From: Marny Stein
Sent: Friday, December 19, 2014 12:55 PM
To: 'trosclair@riverlandssurveying.com'
Cc: Jack Cali (jackcali@drivesoft.net)
Subject: Revisions to Cali/Roberts plat

Re: Resubdivision off of Valcour Lane
Drainage Impact Analysis Review
Destrehan, LA 70047

RE: **PZS 2014-50**
Resubdivision near Valcour Lane

SITE PLAN

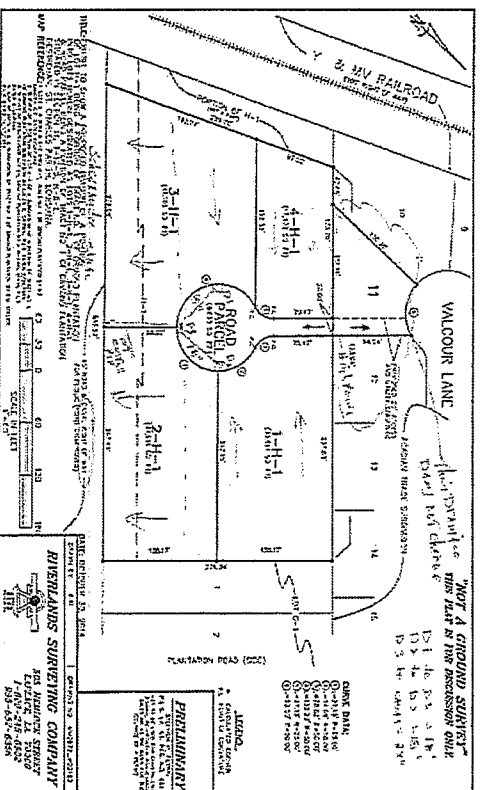
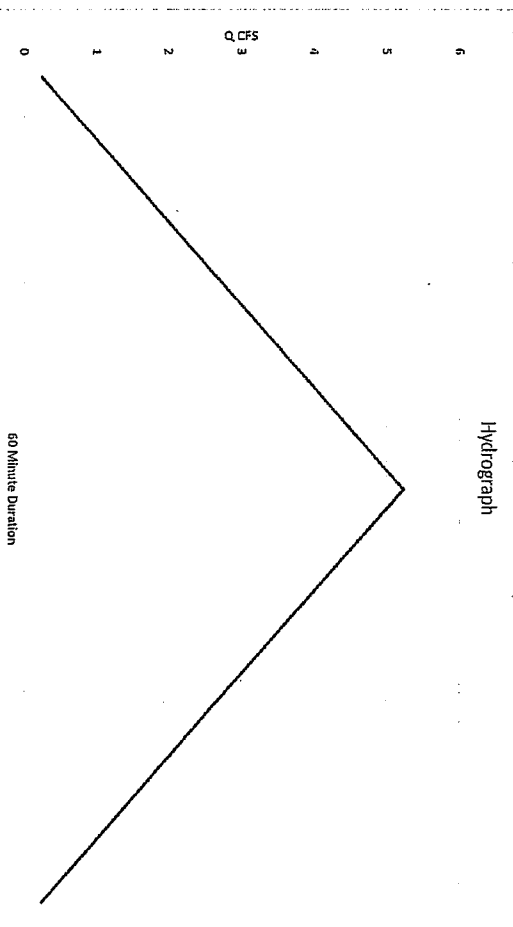
1. The report makes use of an intensity of nine inches per hour (9"/hr) throughout the report. Where did this number come from (what idf curve)?
2. Pre-development model shows an area paved but none are shown on drawings. What area is existing as paved? Is this Lot 11 Valcour Ln?
3. Had drawn watershed map shows a 2% slope on all areas. This will require five feet (5') of fill to be placed on some lots and in the opinion of this office is not practical nor realistic.
4. No areas on the post development calculations are routed to the outfall. Routing flows will cause an increase in post development flows.
5. There are no watershed identifications on the map with corresponding areas.

6. None of the "Canal" area is considered developed. With the hand drawn watershed line drawn through the properties DPW would believe that some of this area is developed.
7. Use of the entire area as storage is not acceptable. With the slopes proposed on the DIA this cannot be achieved.
